Contract #: 04-0120F4
 Cty: SF/ALA Rte: 80 PM: 13.2/13.9
 File #: 69.25B

QUALITY ASSURANCE -- NON-CONFORMANCE REPORT

Report No: NCR-000873

Reference Description: Contractor performed CJP welding on Lift 12 Suspender Brackets without following the D1.5 requirements (No run-off tap)

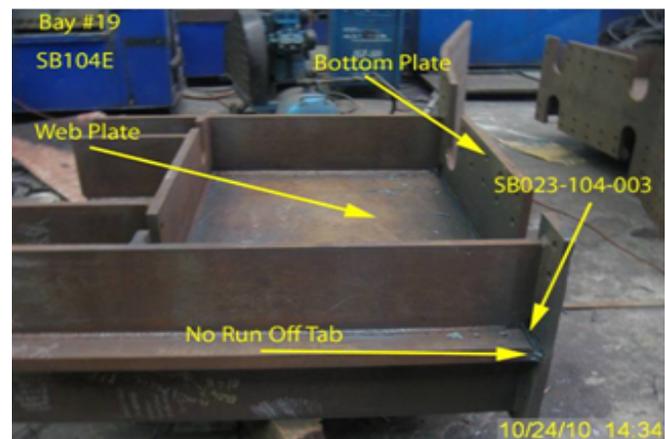
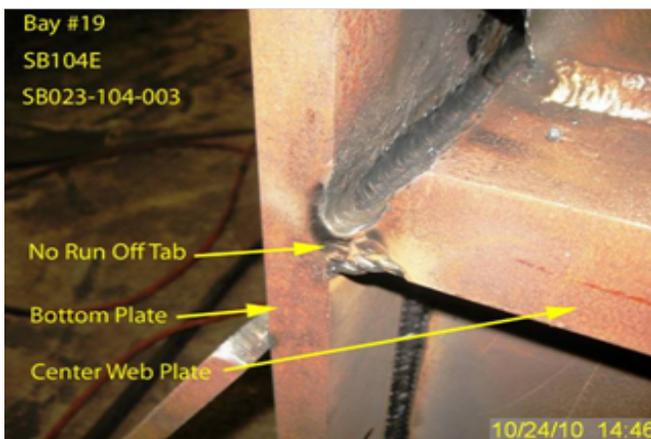
During Quality Assurance (QA) random in-process observations of the fabrication of Lift 12 Suspender Brackets SB104E, SB104W, SB106E, and SB106W, this Caltrans QA inspector discovered the following issues:

- Complete Joint Penetration (CJP) Welding was being performed without using run-off tabs.
- The members are identified as Suspender Brackets for Lift 12.
- The welds are CJP, T joints identified as; SB022-104-003, SB022-106-003, SB023-106-003, and SB023-106-003.
- The welds are joining the Suspender Bracket center web plate to bottom plate.
- OBG Suspender brackets are located in the Bay 19.

American Weld Society (AWS) D1.5 2002 section 3.12.1 "Welds shall be terminated at the end of a joint in a manner that will ensure sound welds. Whenever possible, this shall be done using weld tabs (extension bars and run off plates) placed in a manner that will duplicate the joint detail being welded".

ZPMC is providing NDT of the weld performed with run off tabs to show that the weld was not adversely affected. In the future, ZPMC QC will look for this specifically to ensure that there are run off tabs in place before welding. Based on the acceptable NDT, ZPMC requests closure of this NCR.

The proposed resolution is acceptable. This NCR is considered closed.

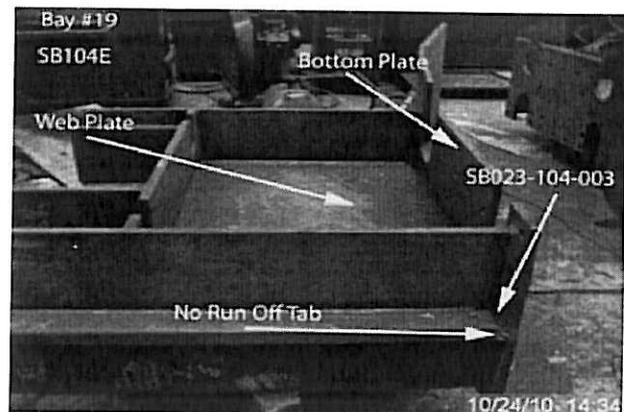
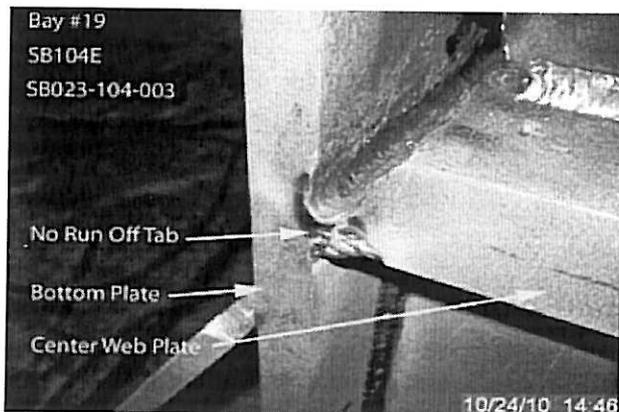
During Quality Assurance (QA) random in-process observations of the fabrication of Lift 12 Suspender Brackets SB104E, SB104W, SB106E, and SB106W, this Caltrans QA inspector discovered the following issues:

- Complete Joint Penetration (CJP) Welding was being performed without using run-off tabs.
- The members are identified as Suspender Brackets for Lift 12.
- The welds are CJP, T joints identified as; SB022-104-003, SB022-106-003, SB023-104-003, and SB023-106-003.
- The welds are joining the Suspender Bracket center web plate to bottom plate.
- OBG Suspender brackets are located in the Bay 19.

American Weld Society (AWS) D1.5 2002 section 3.12.1 "Welds shall be terminated at the end of a joint in a manner that will ensure sound welds. Whenever possible, this shall be done using weld tabs (extension bars and run off plates) placed in a manner that will duplicate the joint detail being welded".

Contractor will perform NDT of the welds without run off tabs to show the welds are not adversely affected. Contractor will remind QC to look for this specifically during fit-up inspections to ensure that run off tabs in place before welding.

Contractor provided the NDT report to prove the welds are acceptable. QCs' were reminded tht specific check on runoff tabs have to be carried out during fit-up inspections.
